Access Compliance Report

Public Rights-of-Way

Intersection ID: 7042	Main Street: BACK_CREEK_DR	Cross Street: E_W_T_HARRIS_BV	Location: SW
ADA ID: 383189698352	Ramp Type: Perp	Initial Pass/Fail: Fail	Overall Compliance: No
		Severity Score: 12.5

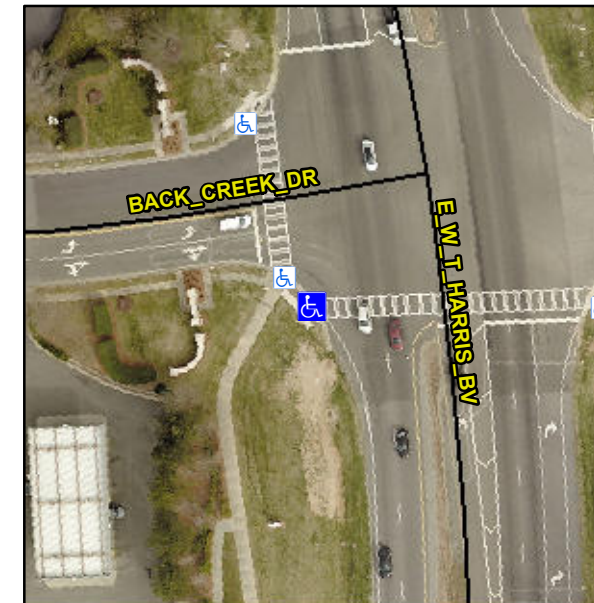
R304.5.3

Compliance	Description	Data	Compliance	Description	Data
N/A	Ramp Length (in)	46.0	Yes	Ramp Slope (%)	7.4
Yes	Ramp Width (in)	48.0	No	Ramp XSlope (%)	6.2
N/A	Flare Type LT	N/A	N/A	Flare Type RT	N/A
N/A	Flare Slope LT (%)	N/A	N/A	Flare Slope RT (%)	N/A
N/A	Flare Traversable LT?	N/A	N/A	Flare Traversable RT?	N/A
N/A	Landing Length (in)	N/A	N/A	DWS Provided?	N/A
N/A	Landing Width (in)	N/A	N/A	DWS Contrast?	N/A
N/A	Landing Slope (%)	N/A	N/A	DWS Length (in)	N/A
N/A	Landing X Slope (%)	N/A	N/A	DWS Full Width?	N/A
N/A	Landing Curb? (Y/N)	N/A	N/A	DWS Offset (in)	N/A
N/A	Shared Landing?	N/A			
N/A	Gutter Ponding?	N/A	N/A	Gutter Slope (%)	N/A
N/A	Gutter Lip Ht (in)	N/A	N/A	Gutter X Slope (%)	N/A
N/A	Painted X Walk1?	Yes	N/A	Painted X Walk2?	N/A
	X Walk 1 Direction	To E		X Walk 2 Direction	N/A
N/A	X Walk 1 Width (in)	110.0	N/A	X Walk 2 Width (in)	N/A
	X Walk 1 Slope (%)	9.7		X Walk 2 Slope (%)	N/A
	X Walk 1 X Slope (%)	0.9		X Walk 2 X Slope (%)	N/A

Remove & Replace Entire Ramp.
